Promoting small biomass power plants in rural Thailand for sustainable renewable energy management and community involvement

Prepared for
The United Nations Industrial Development Organization

Prepared by
The Energy and Resources Institute

This is an interim progress report, which consists of the design improvements and other activities carried out, after submission of the first progress report, in April 2014. The important communications (with questions and answers) related to the various aspects of the projects are provided as annexures (1 -5) to this report. Design of additional components, worked out after submission of the first progress report is:

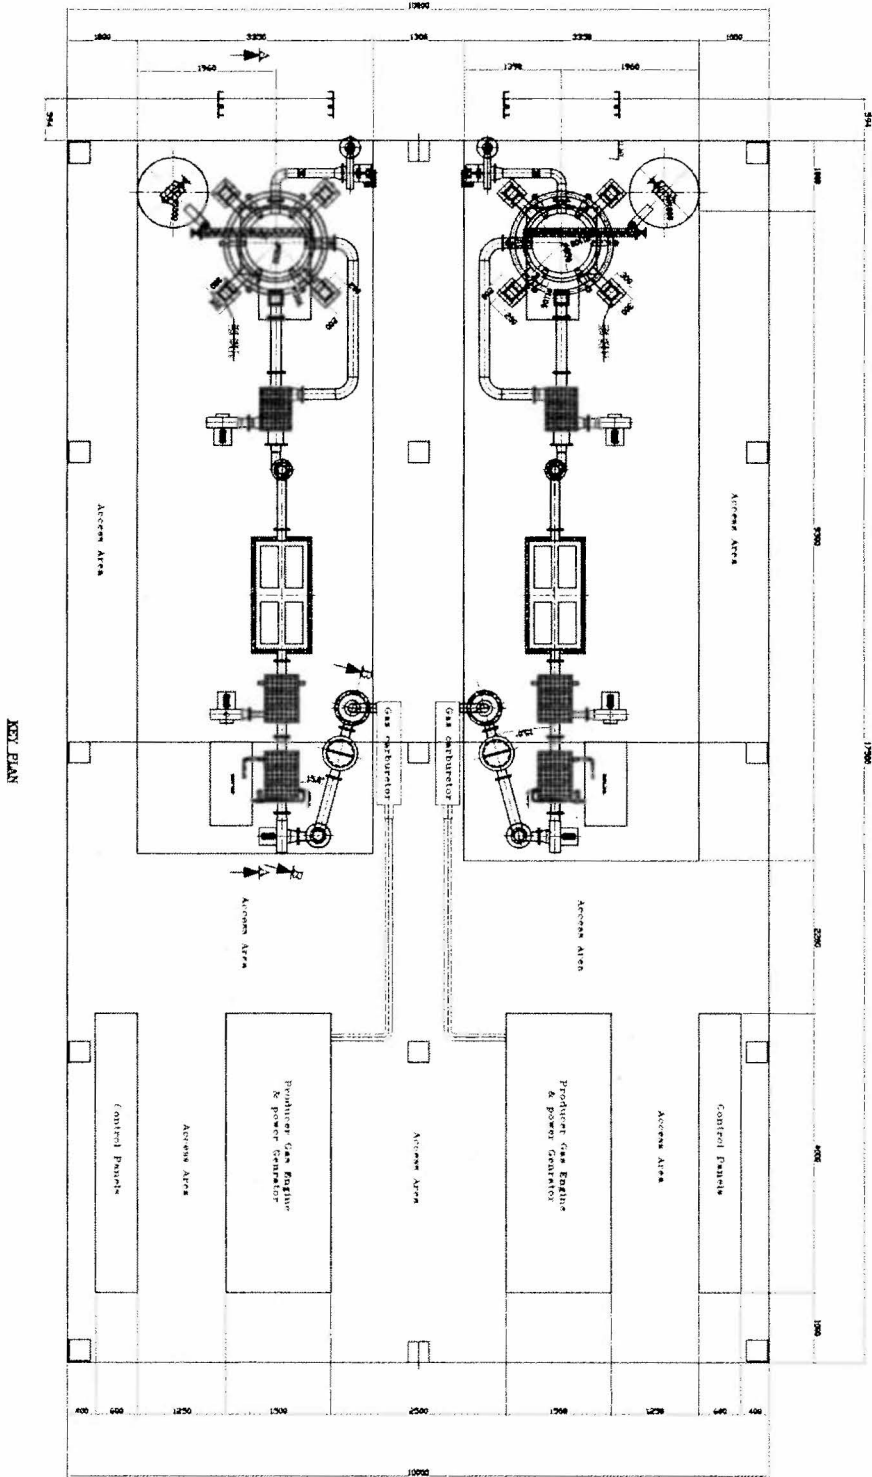
1. The detailed specification/dimension/weight of all machines such as gasifier reactors, gas cleaning systems, blowers, motors, gas engine, etc. as shown in Figure 4 and 5 in TERI 1st progress report.

3. Refer to the Figure 4 in TERI 1st progress report, our project partner wants to know what kind of basement of each machine/equipment? Would you also provide us the dimension of basement of each machine?

The civil construction requirements along with the location of the equipment are provided in the interim progress report, (Annexure 7). A separate drawing on the foundation detail is attached along with this report.

Please refer the civil construction requirements (annexure 7) in the report.

The detailed drawings of the gasifier system are provided in this chapter. The main gasifier unit and the fuel feeding system will be having foundations. The foundation drawings required for these two components are given in detail. The rest of the components will be placed on the floor. These components will be fixed at the ear marked locations using fastener-bolt. The fastener bolts will be sent along with the system, as per the requirement. The foundation work needs to be done as per the drawing, along with the civil construction works. The drawings provide the basic requirement of area and height of the shed. Earlier there was communications regarding the shape of the building and fuel storage. The clarification on this regards may be referred for more details about the civil works.
